Project	<b>IEEE 802.16 Broadband Wireless Access Working Group</b> < <a href="http://ieee802.org/16">http://ieee802.org/16</a> >
Title	<b>Re-definition of Mobile Terminal Management Primitives</b>
Date Submitted	<b>2007-03-14</b>
Source(s)	Jaesun Cha and Chulsik Yoon <a href="mailto:jscha@etri.re.kr">jscha@etri.re.kr</a> ETRI 161 Gajeong-dong, Yuseong-gu Daejeon 305-700 Korea
Re:	Contribution on comments to IEEE 802.16g/D8
Abstract	Re-definition of mobile terminal management primitives
Purpose	Adoption
Notice	This document has been prepared to assist IEEE 802.16. It is offered as a basis for discussion and is not binding on the contributing individual(s) or organization(s). The material in this document is subject to change in form and content after further study. The contributor(s) reserve(s) the right to add, amend or withdraw material contained herein.
Release	The contributor grants a free, irrevocable license to the IEEE to incorporate text contained in this contribution, and any modifications thereof, in the creation of an IEEE Standards publication; to copyright in the IEEE's name any IEEE Standards publication even though it may include portions of this contribution; and at

Figure 505 – M-MTM primitives flow for Reset / ~~Power On~~ / Power Down at MSSS side

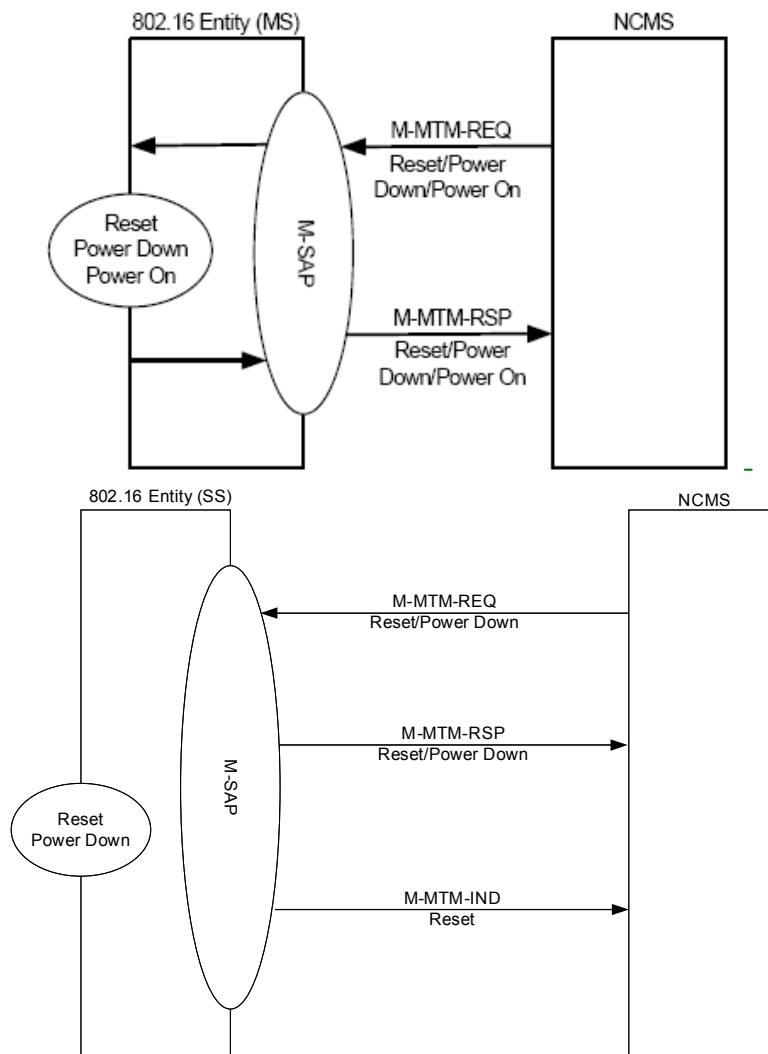
Some of mobile terminal management primitives are not defined correctly. For example, M-MTM-REQ (Power On) primitive is generated to force the terminal to power on. But, the terminal can not receive the primitive because it has already been powered off.

Primitives	Changes	Reason for Changes
M-MTM-REQ (Power on) M-MTM-RSP (Power on)	<ul style="list-style-type: none"> <li>➤ Remove two primitives</li> <li>➤ Add a new primitive; M-MTM-IND (Power On)</li> </ul>	<ul style="list-style-type: none"> <li>➤ We can't give any instruction to the device which is powered off.</li> </ul>
M-MTM-REQ (Power Down) M-MTM-RSP (Power Down)	<ul style="list-style-type: none"> <li>➤ The SS generates M-MTM-RSP (Power Down) primitives before it starts power-down procedure.</li> </ul>	<ul style="list-style-type: none"> <li>➤ After power-down, the SS can't generate any primitive.</li> </ul>
M-MTM-REQ (Reset) M-MTM-RSP (Reset)	<ul style="list-style-type: none"> <li>➤ If NCMS at SS side generates the request primitive, the SS performs reset procedure after it responds to the request. And then, it generates M-MTM-IND (reset) primitive to notify the NCMS of the completion of reset.</li> <li>➤ If NCMS at BS side uses M-MTM-REQ (reset) primitive instead of M-MTM-IND (reset) primitive to reset the terminal</li> </ul>	<ul style="list-style-type: none"> <li>➤ It's better to use one unified primitive to notify the NCMS of a reset event; M-MTM-IND (reset)</li> <li>➤ The generation of M-MTM-IND (reset) by the NCMS at BS side is not the event notification. It's just a request to reset the terminal</li> </ul>

Figure 507 – M-MTM primitives flow for Hold and Normal resumption

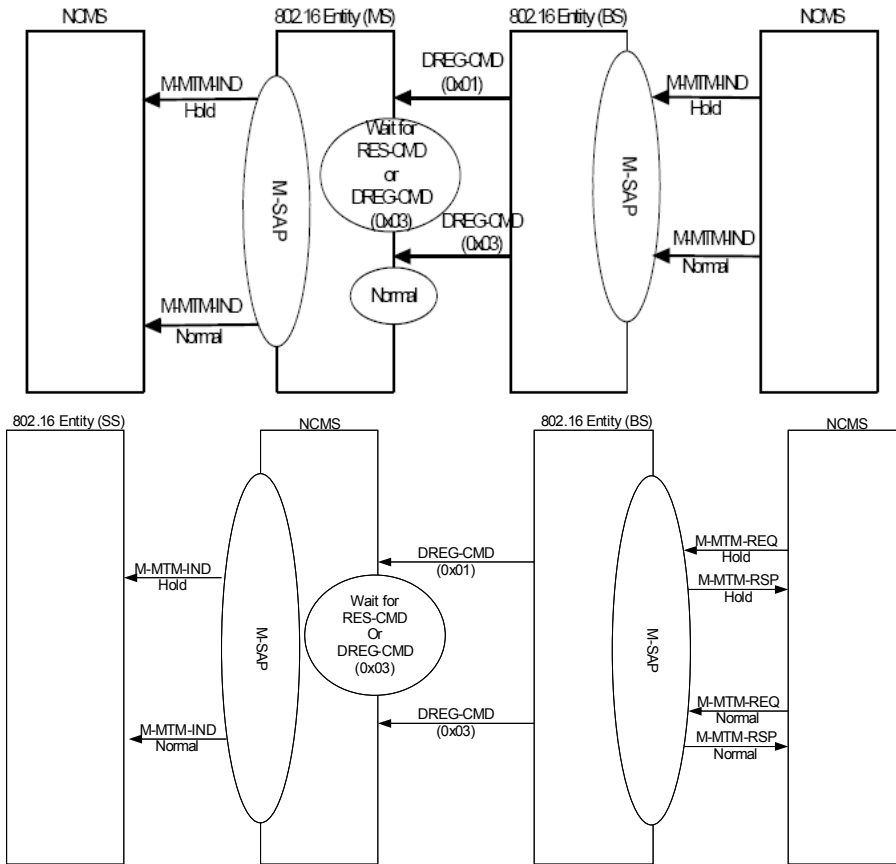
Another example is the primitives used to change the status of the terminal. Generally, an indication primitive is used to notify any event. But, in the current draft, the NCMS uses an indication primitive to request the terminal to change the current status.

M-MTM-IND (Hold)	<ul style="list-style-type: none"> <li>➤ Only SS can generate M-MTM-IND (Hold) primitive.</li> <li>➤ The new primitives are used at BS side; M-MTM-REQ (Hold), M-MTM-RSP (Hold)</li> </ul>	<ul style="list-style-type: none"> <li>➤ The generation of M-MTM-IND (Hold) by the NCMS at BS side is not the event notification. It's just a request to change the status of the terminal</li> </ul>
M-MTM-IND (Normal)	<ul style="list-style-type: none"> <li>➤ Only SS can generate M-MTM-IND (Normal) primitive.</li> <li>➤ The new primitives are used at BS side; M-MTM-REQ (Normal), M-MTM-RSP (Normal)</li> </ul>	<ul style="list-style-type: none"> <li>➤ The generation of M-MTM-IND (Normal) by the NCMS at BS side is not the event notification. It's just a request to change the status of the terminal</li> </ul>
